SUBJECT: ST. LUCIE PLANT, UNITS 1 AND 2 - STAFF ASSESSMENT AND CLOSURE OF INFORMATION PROVIDED PURSUANT TO TITLE 10 OF THE *CODE OF FEDERAL REGULATIONS* PART 50, SECTION 50.54(f), SEISMIC HAZARD REEVALUATIONS FOR RECOMMENDATION 2.1 OF THE NEAR-TERM TASK FORCE REVIEW OF INSIGHTS FROM THE FUKUSHIMA DAI-ICHI ACCIDENT" (CAC NOS. MF3940 AND MF3941)

Enclosure:  
Staff Assessment of Seismic  
Hazard Evaluation and Screening Report

ST LUCIE PLANT, UNITS 1 AND 2

Figure 3.3-1 Plot of Staff's and Licensee's Base Case Shear-Wave Velocity Profiles

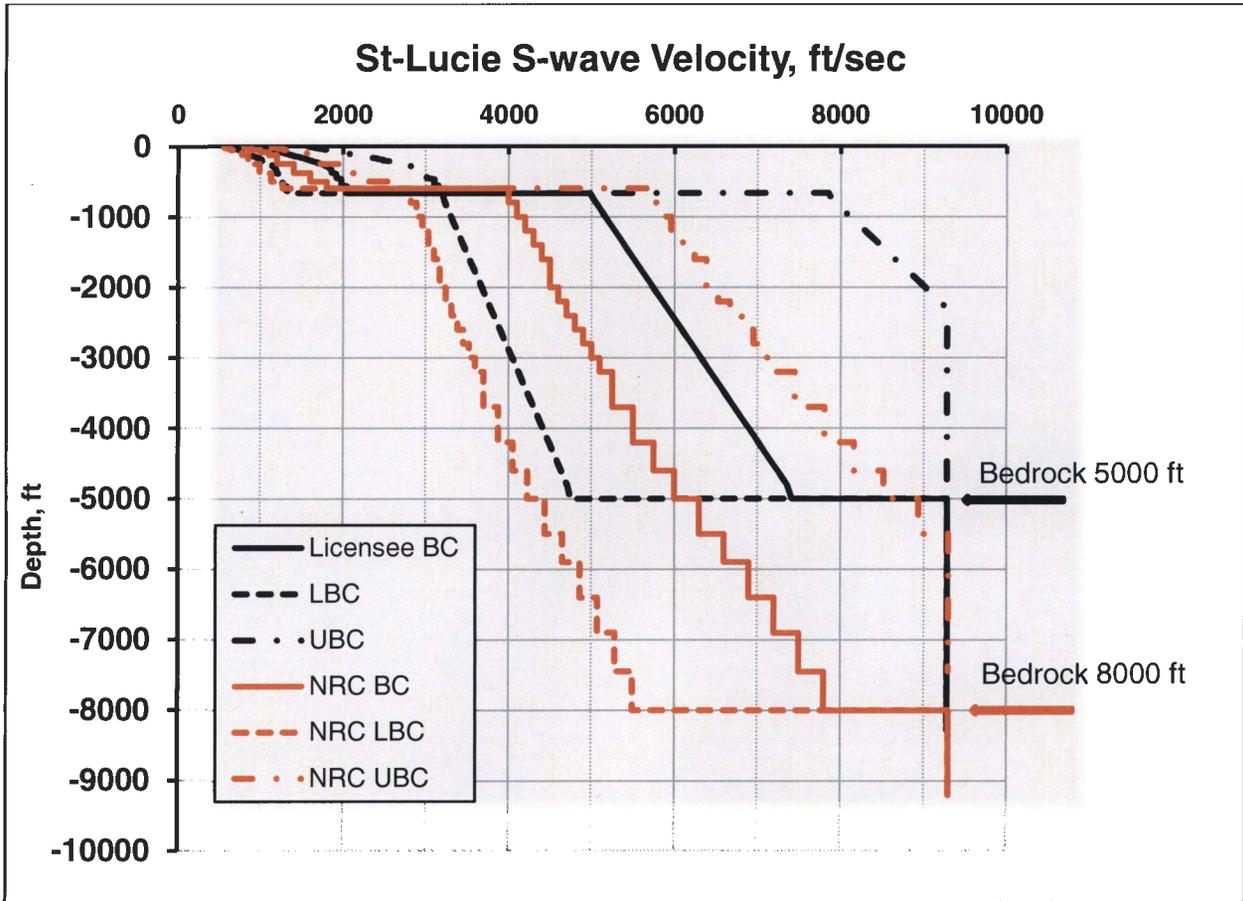
the licensee assumed that the reference rock velocity of 9,285 ft/sec (2,890 m/sec) is reached at a depth of 2,323 ft (708 m) below the control point elevation. Figure 3.3-1 of this assessment shows the licensee's three shear-wave velocity profiles.

To develop its best estimate base case velocity profile, the NRC staff used the measured on-site velocity information over the upper 160 ft (48.8 m). Below this depth, the NRC staff developed a velocity profile based on the soil type and rock lithologies for the region. The staff's best estimate base case profile generally demonstrates similar behavior as the licensee's profile except the staff's profile shear-wave velocity increases gradually below the depth of 600 ft (182.9 m) from 4000 ft/sec (1,219 m/sec) to 7800 ft/sec (2377 m/sec) at the presumed bedrock depth of 8000 ft (2438 m). To capture the uncertainty in the site subsurface geology, the NRC staff developed three base case shear-wave velocity profiles using a scale factor of 1.57, which corresponds to a natural log standard deviation of 0.35. Figure 3.3-1 of this assessment shows the NRC staff velocity profile compared to the base case profiles developed by the licensee. The profiles developed by the NRC staff have lower seismic velocities and have a deeper depth to base rock than those developed by the licensee. The NRC staff randomized the depth to base rock by  $\pm 20$  percent to allow for additional uncertainty.

Figure 3.3-1 Plot Comparing the Staff's and the License's Median Amplification Functions and Uncertainties

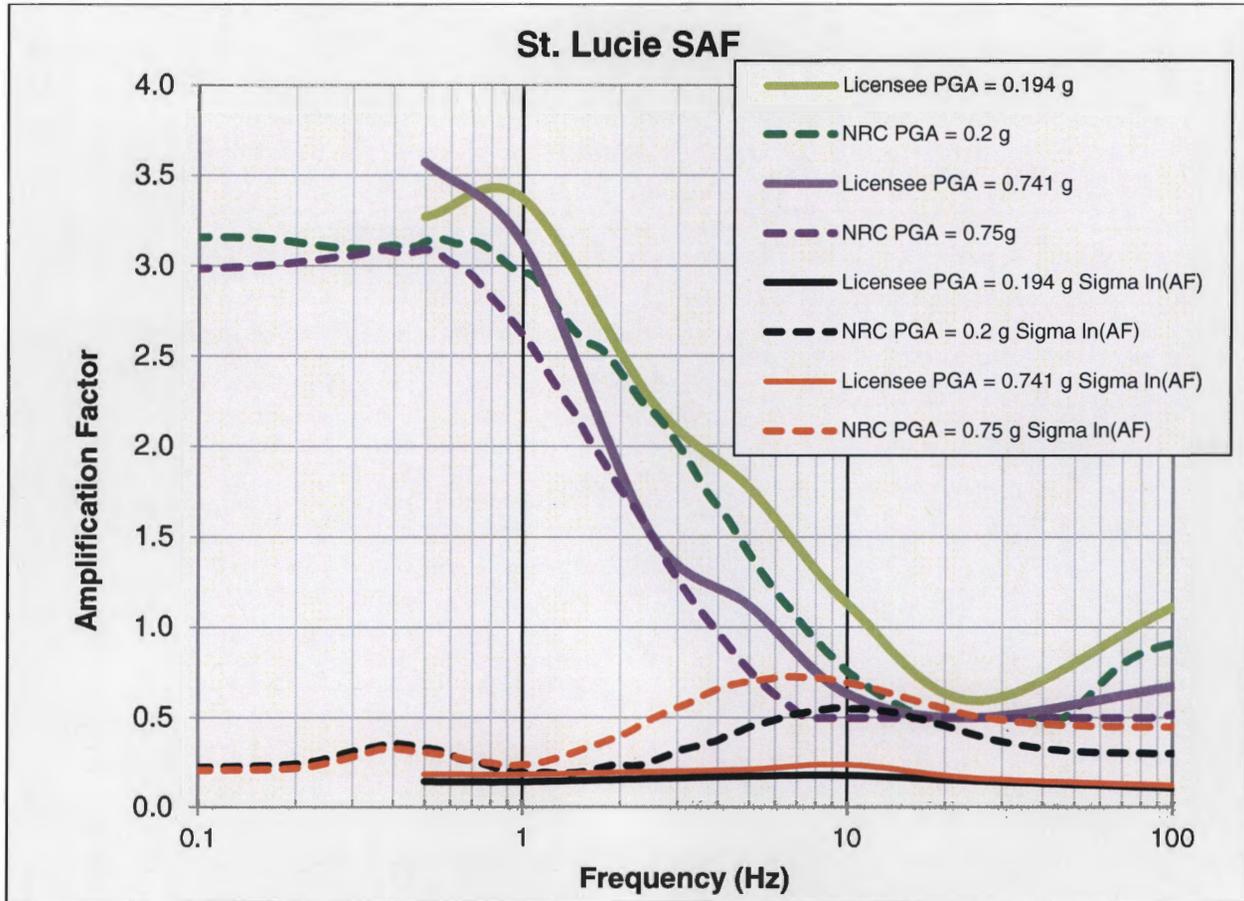
To determine kappa for its profiles, the NRC staff used the low strain damping values, shear wave velocities, Q-values, and layer thicknesses for each layer to arrive at kappa values for the best estimate, upper, and lower base case velocity profiles of 0.033, 0.016, 0.040 sec, respectively. Figure 3.3-2 of this assessment shows a comparison of the NRC staff's and licensee's median site amplification functions and uncertainties ( $\pm 1$  standard deviation) for two of the eleven input loading levels. Due to the differences in shear-wave velocity profiles the staff's amplification functions are slightly lower than those of the licensee's. In addition, the staff's amplification factor uncertainties are somewhat higher than the licensee's for the two loading levels.

Figure 3.3-2 Plot Comparing the Staff's and the Licensee's Mean Control Point Hazard Curves at a Variety of Frequencies

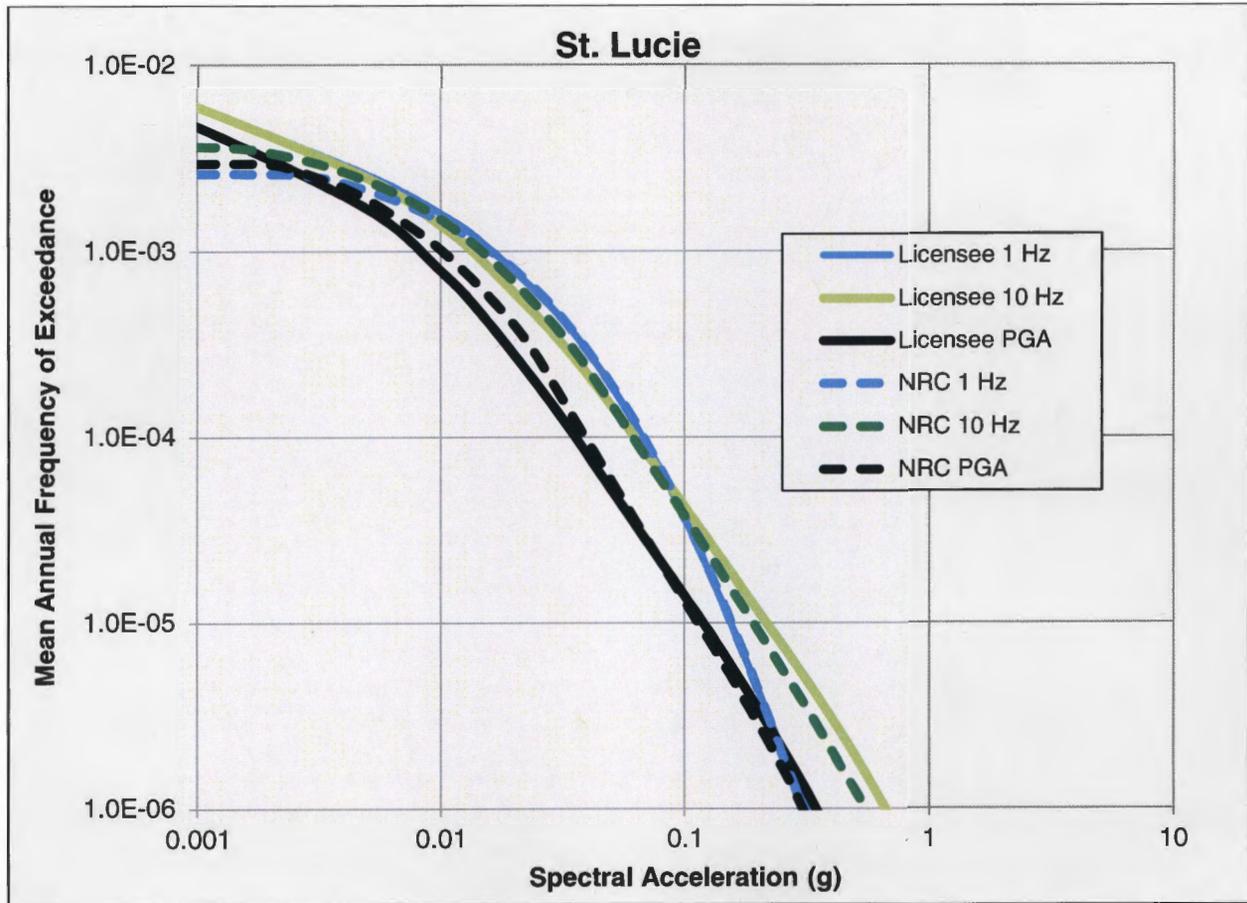
As shown in Figure 3.3-3 of this assessment, these differences in the site response analysis do not have a large impact on the control point seismic hazard curves or the resulting GMRS, as discussed below. Figure 3.3-3 shows that between the  $10^{-4}$  and  $10^{-5}$ , the staff's and licensee's control point hazard curves are similar. Appendix B of the SPID provides guidance for performing site response analyses, including capturing the uncertainty for sites with less subsurface data; however, the guidance is neither entirely prescriptive nor comprehensive. As

Figure 3.4-1 Comparison of the Staff's GMRS, Licensee's GMRS and the St. Lucie Unit Nos. 1 and 2 SSE.

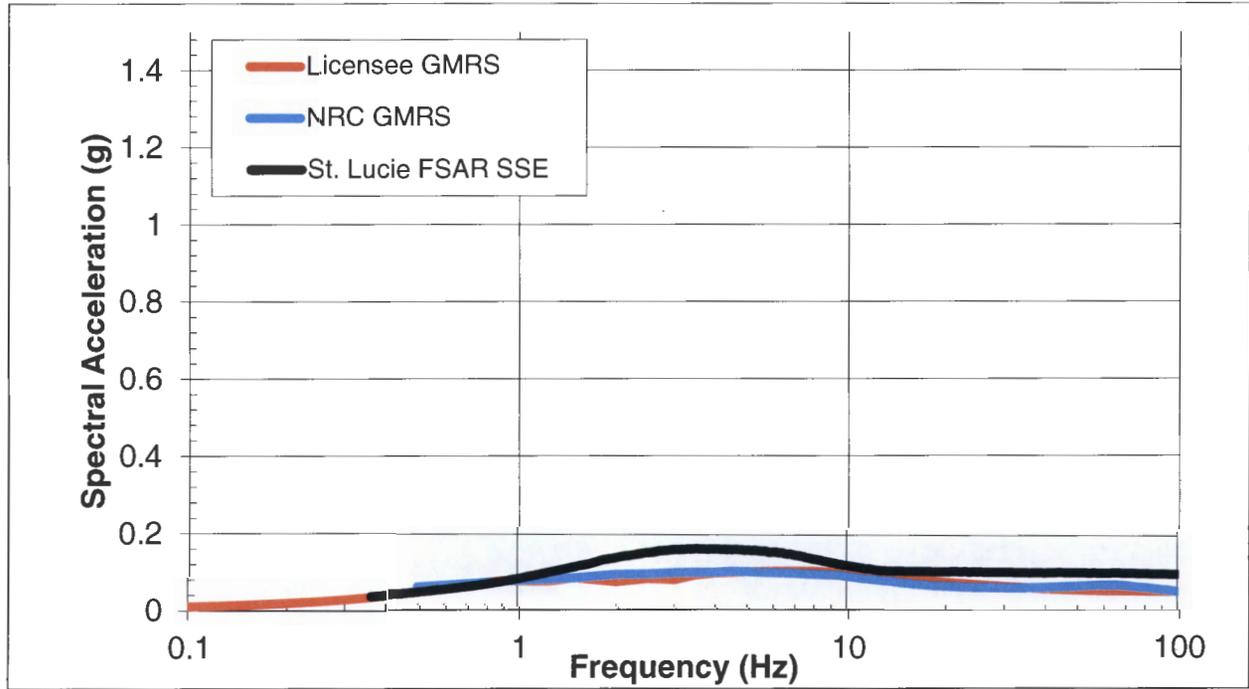
The NRC staff independently obtained the  $10^{-4}$  and  $10^{-5}$  UHRS using the results of its confirmatory PSHA and site response calculations described in Sections 3.2 and 3.3 of this NRC staff assessment, respectively. Figure 3.4-1 of this assessment shows a comparison of the GMRS determined by the licensee to that determined by the NRC staff.

As shown in Figure 3.4-1 of this staff assessment, the licensee's GMRS shape is similar to the staff's GMRS across the entire frequency range, although the licensee's GMRS has a flatter profile at high frequencies than the NRC's GMRS. The NRC staff also noted that the NRC's SSE differs from that of the licensee in both shape and spectral acceleration. The NRC's SSE is also a smoother curve than the licensee's with a lower spectral acceleration.

The NRC staff confirms that the licensee used the present-day guidance and methodology outlined in RG 1.208 and the SPID to calculate the horizontal GMRS, as requested in the 50.54(f) letter. The NRC staff performed both a PSHA and site response confirmatory analysis and achieved results consistent with the licensee's horizontal GMRS. As such, the NRC staff concludes that the GMRS determined by the licensee adequately characterizes the reevaluated hazard for the St. Lucie site. Therefore, this GMRS is suitable for use in subsequent evaluations and confirmations, as needed, for the response to the 50.54(f) letter.
